# BENT GRASS PLAZA

### GRADING & EROSION CONTROL DOCUMENTS

GRADING & EROSION CONTROL PLANS FOR:  
**BENT GRASS PLAZA**  
BENT GRASS MARKET VIEW  
EL PASO COUNTY, COLORADO

ISSUE	DATE
INITIAL ISSUE	10/06/2023
2ND SUBMITTAL	11/17/2023
DESIGNED BY:	CGH
DRAWN BY:	SDM
CHECKED BY:	KGV
FILE NAME:	21814-01ECCV

INITIAL GRADING & EROSION CONTROL PLAN  
 PROJECT NO. 21814-00CSCV  
 DRAWING NO.

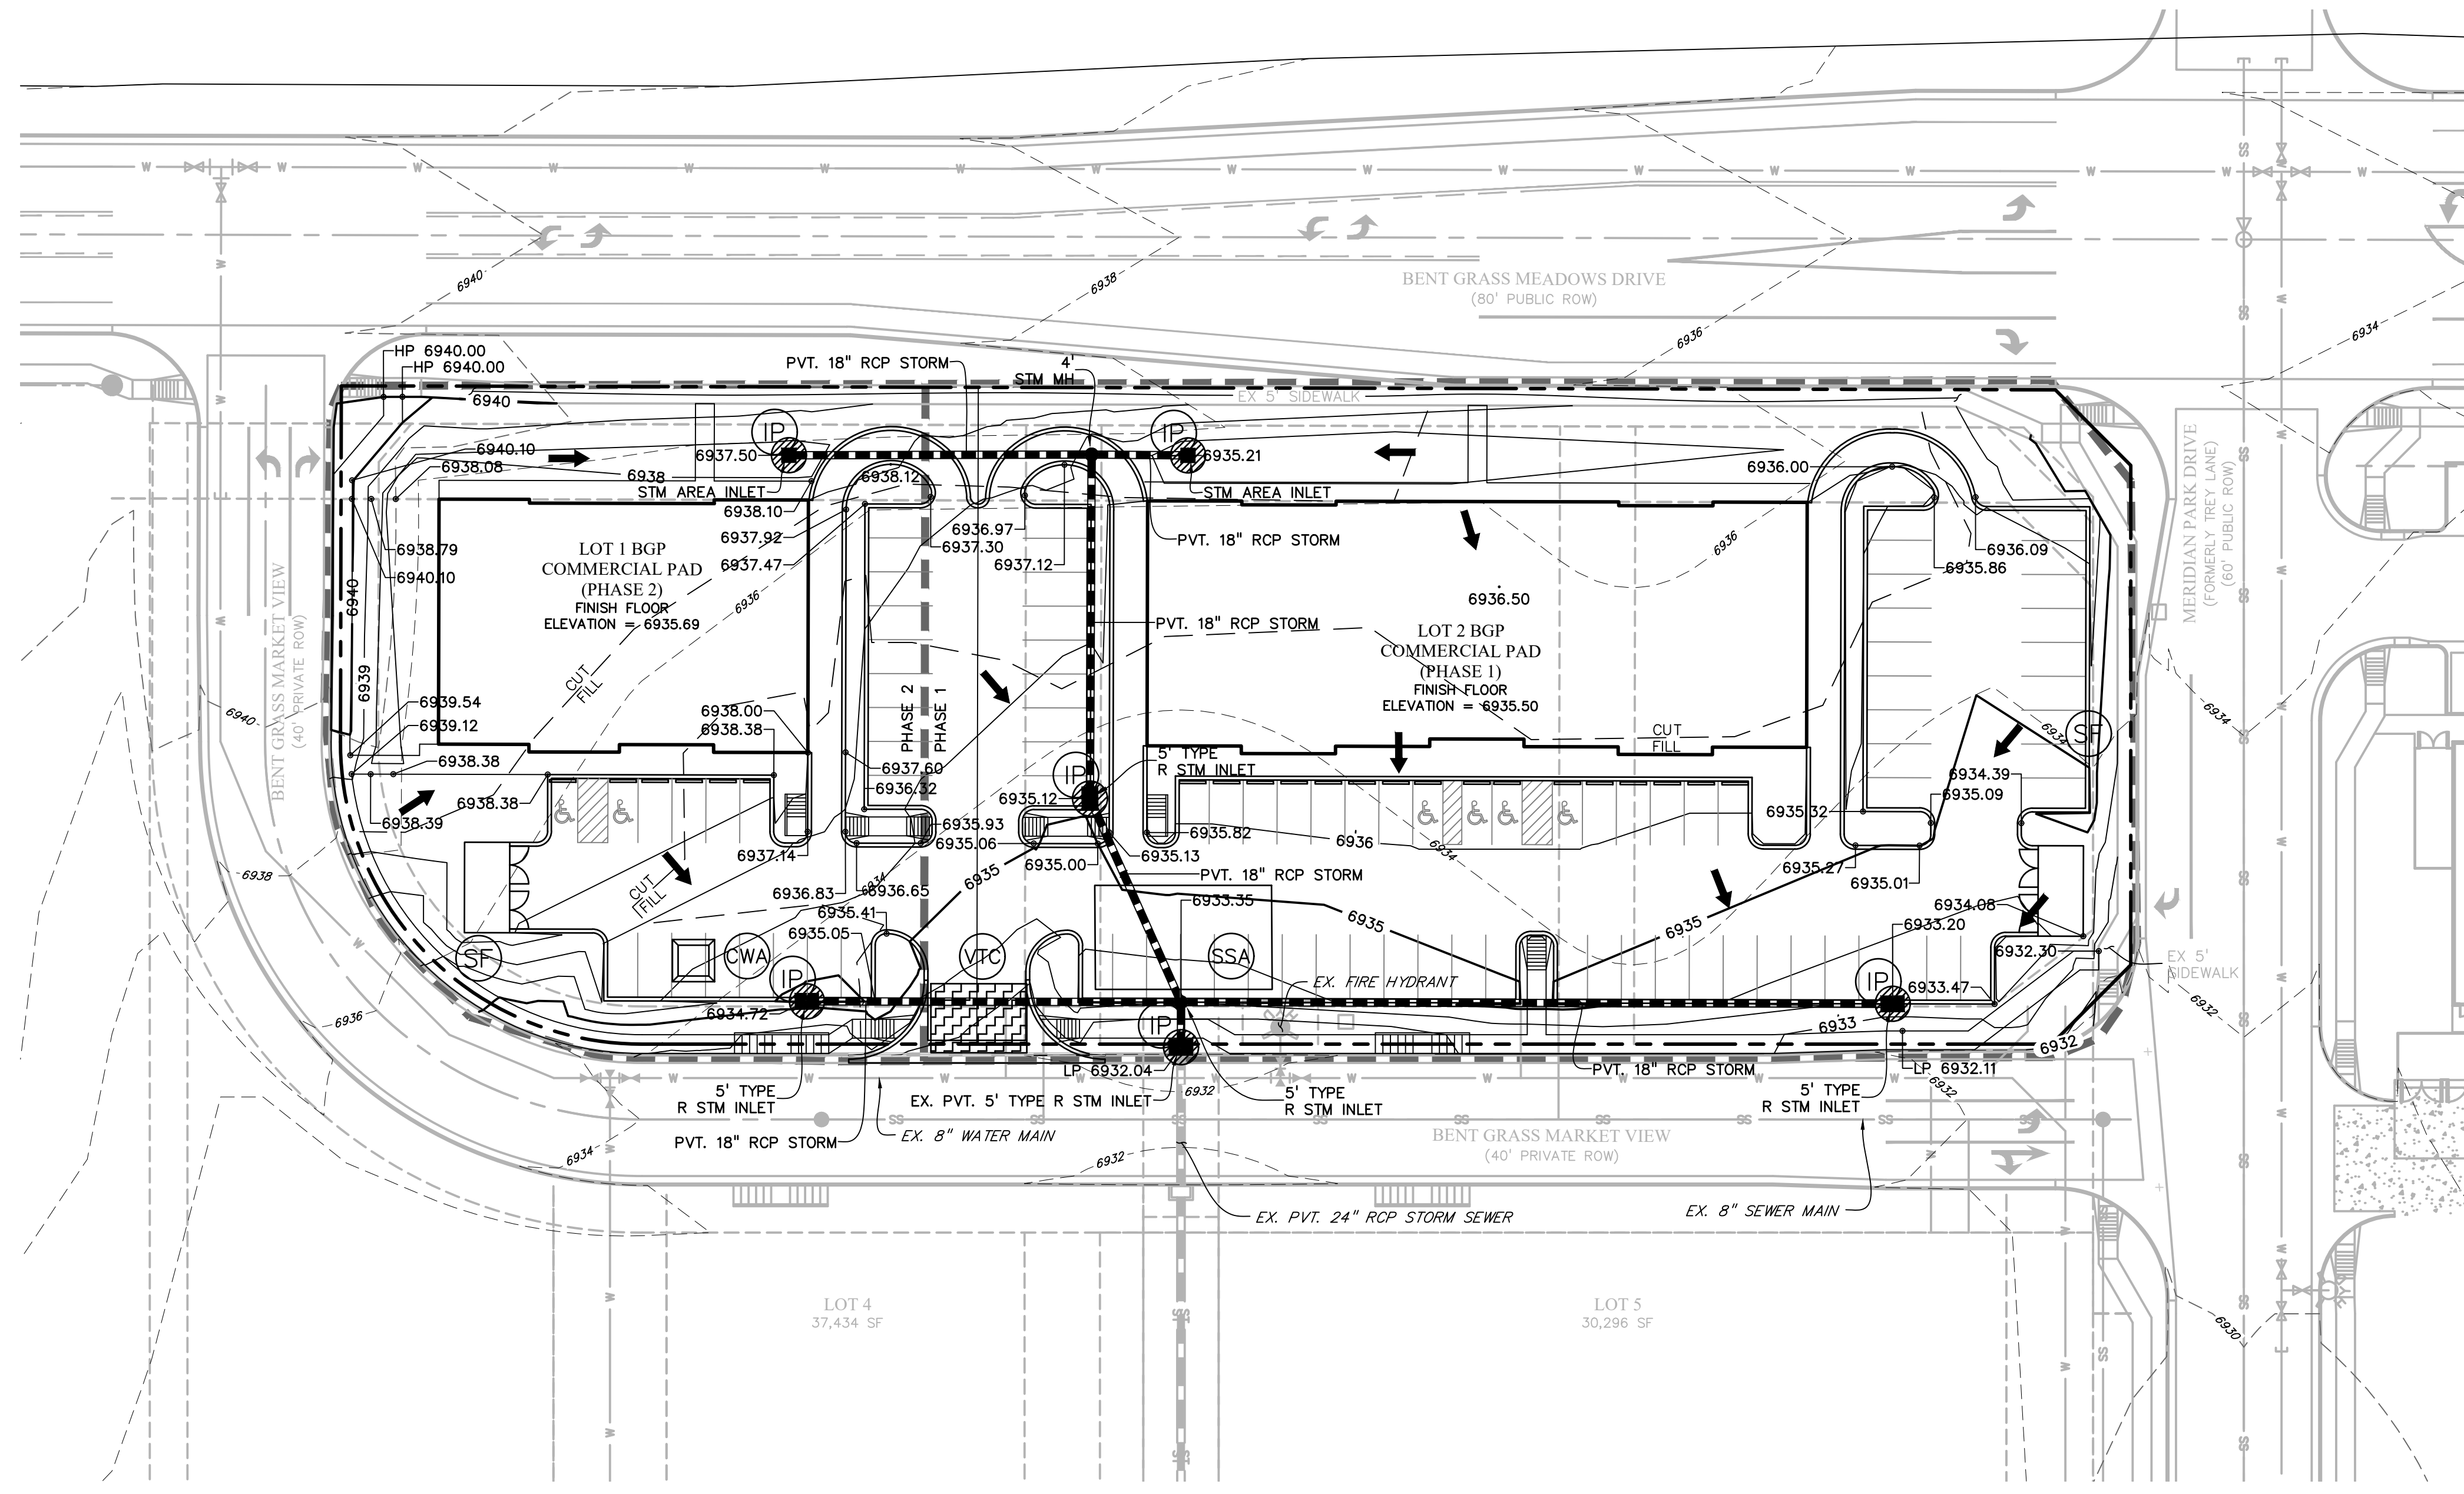
Unresolved Review 1 comment:  
 GEC Checklist Item "x" -  
 I recognize that this is a relatively small site that has been previously overlot graded. However, this checklist item requires TSB's for areas of disturbance >1ac. This would not be required if an explanation can be added to the Drainage Letter or SWMP that describes the phasing of the construction such that there won't be >1ac of disturbance at 1 time (especially prior to the installation of the inlets) or include a couple of Sediment Traps (only suitable for tributary disturbances <1ac) instead of 1 TSB. Show temporary swales that will convey runoff from disturbances to the Traps or TSB.
